TECHNICAL BULLETIN

[Issue No.] T10-0020-A

[Title] Change of the ROM_BIOS Versions Compatible
with the Memory Board for Option Functions

[Relevant Models] A985GOT(-V), A975GOT, A970GOT, A960GOT, A956WGOT

4. Error message displayed when installing the memory board

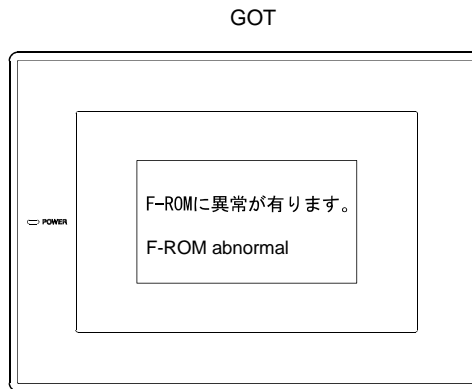
If a memory board of hardware version B or later is mounted in a GOT installed with ROM_BIOS version L or earlier, the following message will appear and the GOT will stop.

If the above message appears, upgrade the ROM_BIOS version by reference to the GT Designer manual.
